**Finance and Performance Committee**  
**ATTACHMENTS - UNDER SEPARATE COVER**

<b>TABLE OF CONTENTS</b>	<b>PAGE</b>
<b>10. Hearings Panel report to the Council on the Te Kaha Surrounding Streets</b>	
A. TG145801 Te Kaha - Plans for Approval.....	3
B. Option 1 - Lichfield Street Te Kaha Improvements For Council Approval.....	11
C. Option 3- Lichfield Street Te Kaha Street Improvements For Council Approval .....	12
D. Te Kaha Hearings Panelists Queries and Staff Responses.....	13
E. Te Kaha Event Management Plan - Abley Report .....	49
F. 2022 Revised Scheme Safety Audit Report Te Kaha Surrounding Streets.....	102
G. 2023 Lichfield Street Safety Audit Report.....	180

**DRAFT TE KAHA ADJACENT STREETS HEARINGS PANEL – QUESTIONS AND RESPONSES**

Figure 2-11: National Speed Limit Register – Huanui Lane.

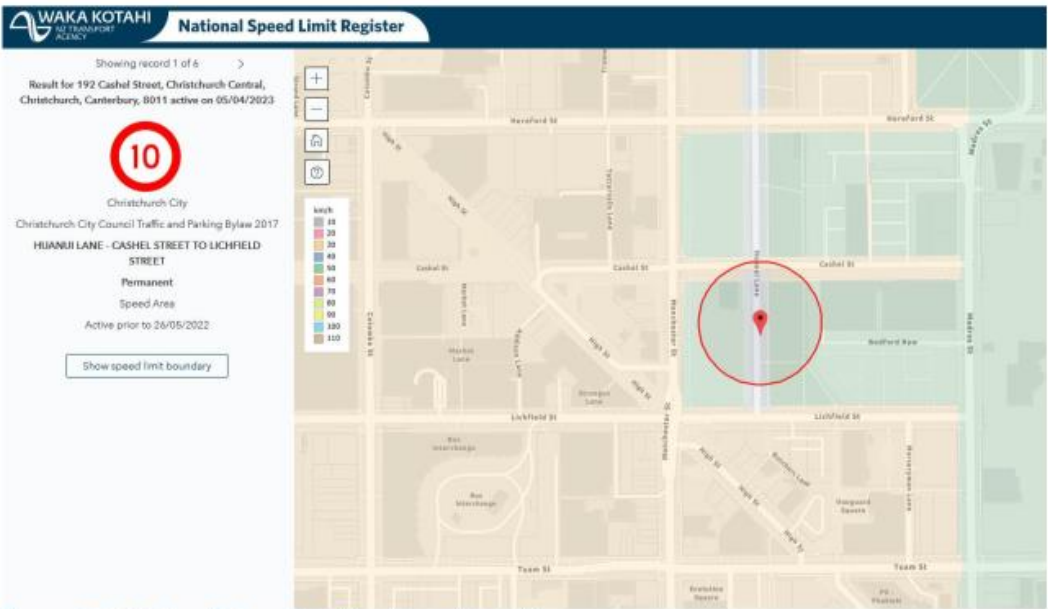
The lack of 10 km/h signs on Huanui Lane could result in adverse speed on the shared use facilities constructed.

Figure 2-19: Proposed Road Cross Section.

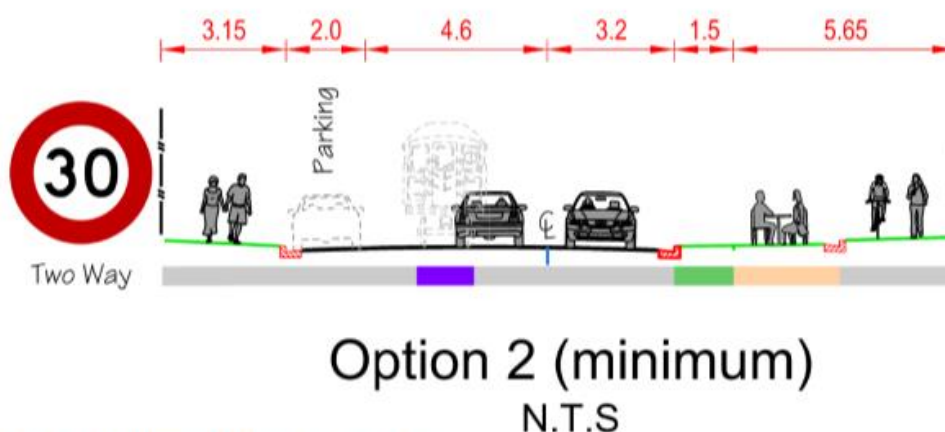
Option 2 is characterised by a moderate width footpath (north side) kerbside parking (north side), two traffic lanes, tram tracks, kerbside dining / engagement area (south side), mid-path kerb (south side) and footpath (south side). The engagement / dining area and footpath (south side) is 5.65 metres in width but split by a vertical face of the kerb.

Figure 2-21: Proposed Road layout.

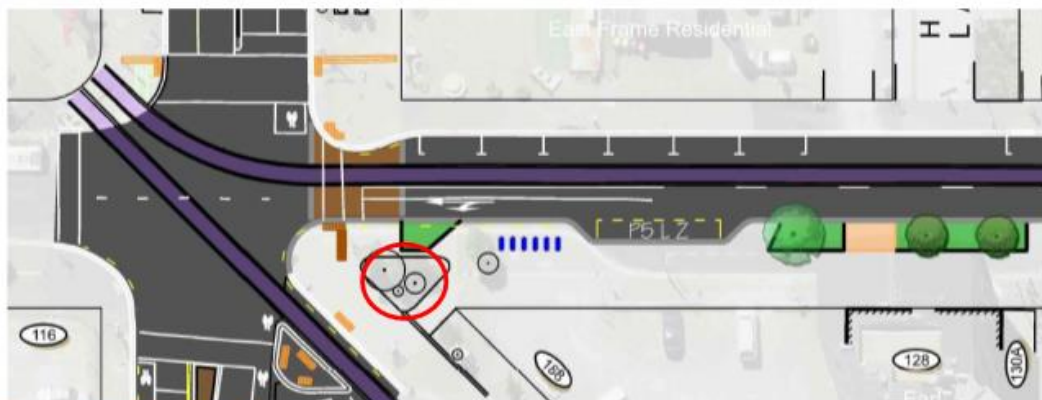
The Manchester Street end threshold forms a narrow pedestrian crossing facility and would result in significant overspill of pedestrians during moderate sized events. The design retains the existing kerb edge in this location (See [Figure 2-21](#) below). Modifications to this kerb line, enabling a wide crossing facility to be formed that would be more conducive to mass pedestrian movement.
